SUBJECT: Addendum No. 2

REFERENCE: Invitation To Bid (ITB) for IDO Building Standards Space Fit-Out; Solicitation No. HJA-IDOBLDG-2022-006; Project No. 913

IDO Building Standards Space Fit-Out

Attachment - Corrected square footage for IDO Space Fit-Out.

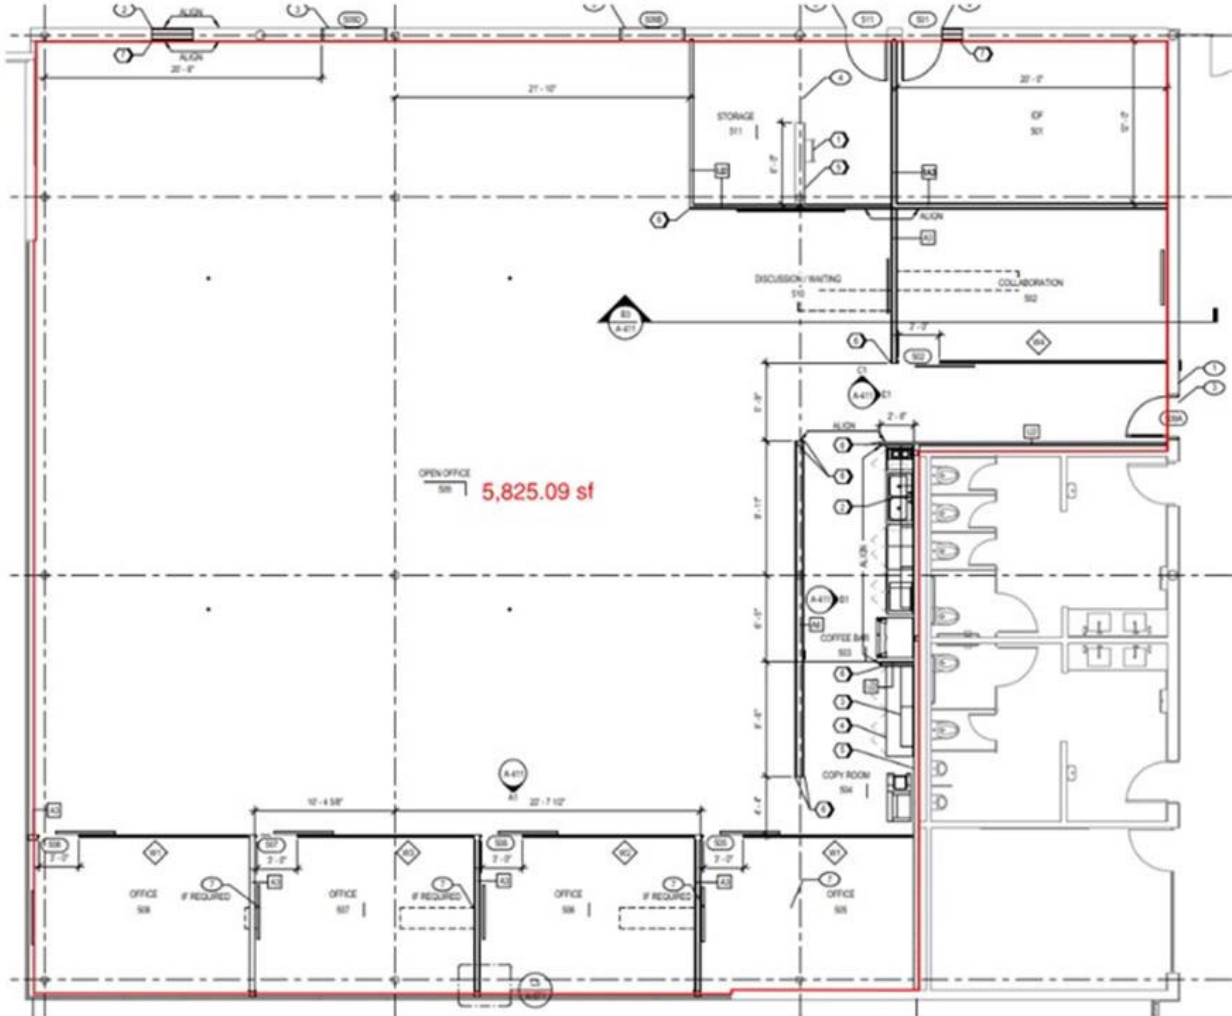
17. **Question:** What is the correct square-footage of the worksite area?

Response: Corrected square-footage is approximately 5,825.09 (see attachment).
